# **Technical Memorandum** ***Review of Impacts from Proposed SR-A1A Widening***

**Date:** November 30, 2022  
**CMA Proj No.:** 431.029  
**Client:** Town of Palm Beach - Department of Public Works

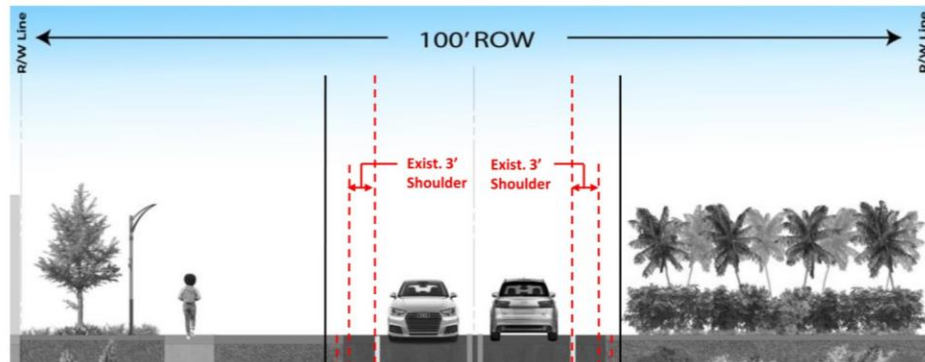
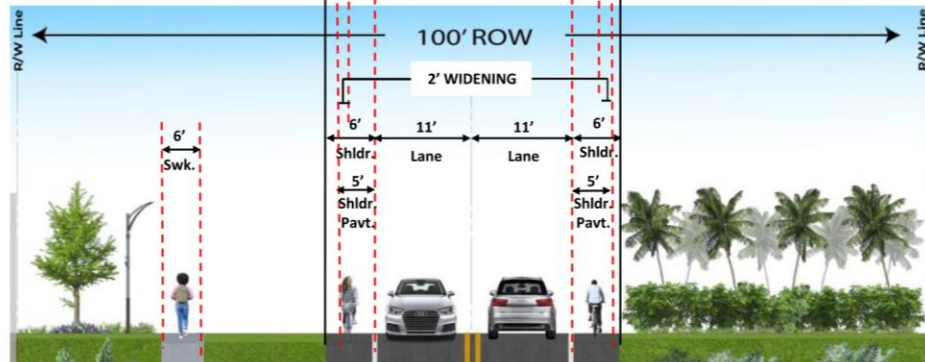
Following the June 2022 workshop, alternatives to the design were considered by FDOT staff. On October 10, 2022, the Town's Public Works Department had a follow-up meeting with the FDOT which concluded with the possibility of a shared use path for bikes and pedestrians in the green space along this corridor instead of incorporated with the roadway. FDOT recognized that there is only a pathway on the west side of the roadway which is different than their typical shared use path configurations, but they are considering a modification to their typical condition for this case. The new proposed improvement would still include widening the path from 6-feet to 10-feet.

FDOT is also proposing to widen the roadway shoulder by 2-ft in both directions as part of the revised configuration. This would create a 5-ft wide paved shoulder instead of the current 3-ft shoulder. When comparing the conceptual plan revision to the original proposed improvements, the main difference is the roadway width is decreased by 1-ft on each side. FDOT provided the exhibit below to illustrate this change (proposed widening of the path not included). The revised plan is a conceptual revision; no design drawings have been prepared.

The other significant change from the original proposal is with the proposed pavement marking plan. The FDOT staff discussed applying new pavement marking to the path on the west side of the road to indicate it is a “shared use path” for pedestrians and bicyclists. Also discussed was not including bicycle lane markings in the newly widened shoulders.
